STORMWATER & FLOOD MANAGEMENT REVIEW

Huntlee New Town Residential Development – Modification 20

Lot 34 DP 755211

April 19, 2022

FIGURE 4 – Rainfall Data & Catchment Areas

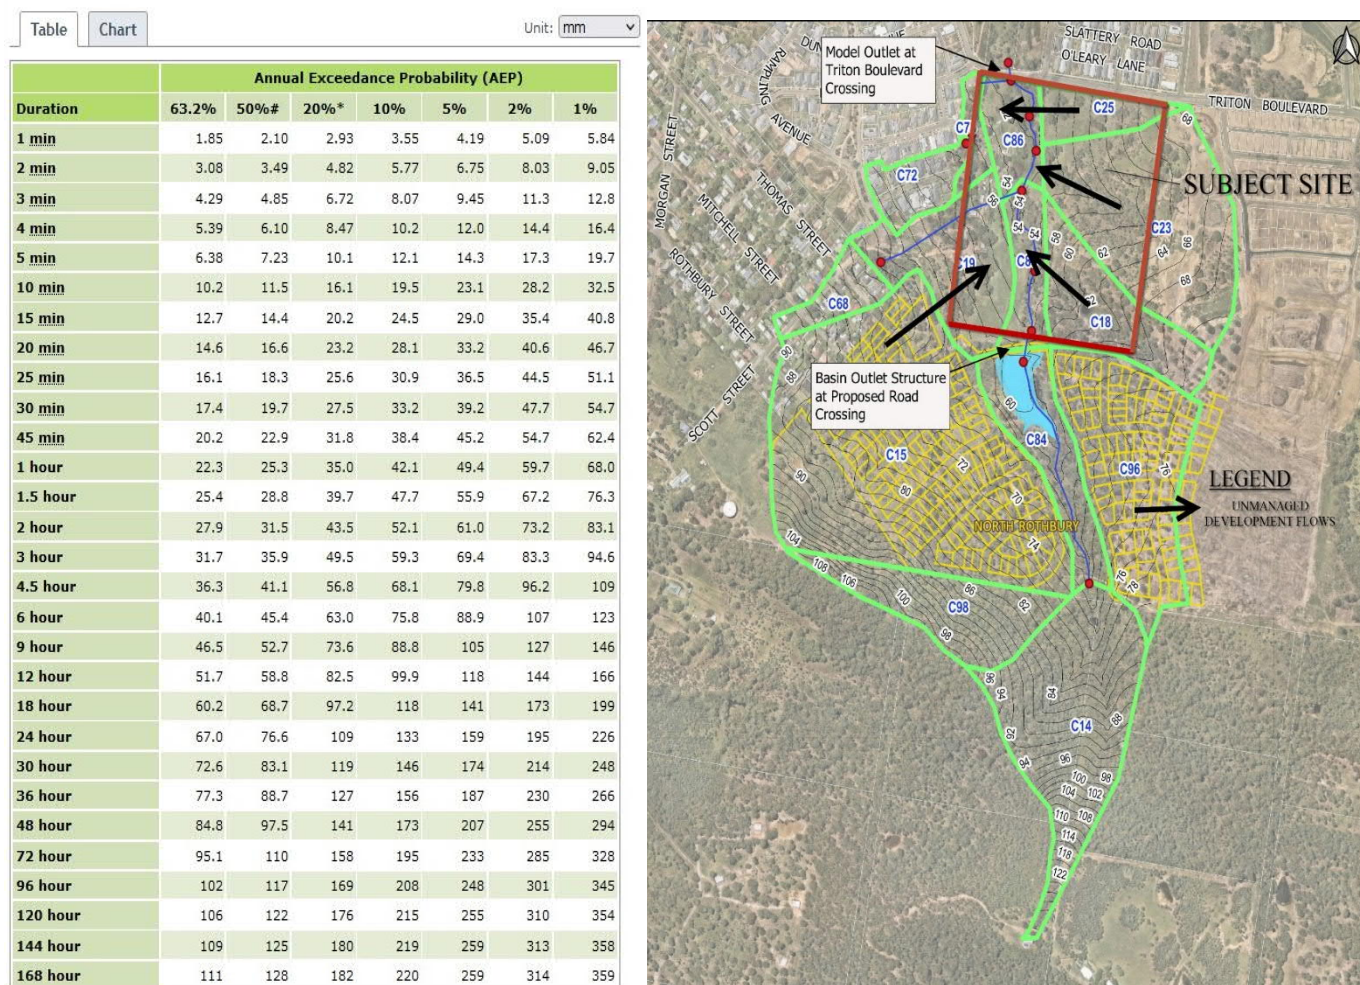
- Rainfall Depths – access to the BOM web site has yielded the rainfall depths shown in the adjacent table. Although the depths for 20%, 10% and 1% AEP events appear consistent – the 50% AEP storm events do not. Can this please be clarified?

- The Designers have suggested a 65% fraction impervious for the developed catchment areas. Can this value be justified please?
- The Designers have not elaborated on the need for detailed erosion and scour protection at the outlet of Basin 3. Given that outlet velocities greater than 4m/sec are expected it is considered necessary that some form of energy dissipation would be required at the outlet. It is suggested that an 11m long rock apron will not mitigate the erosion issues that may occur as a consequence of these velocities.

- It is noted that the Designers have opted to use a 0% fraction impervious for some of the impervious catchments. It is suggested that no catchment is 0% impervious and that a minimum value for rural type catchments should be 10%.
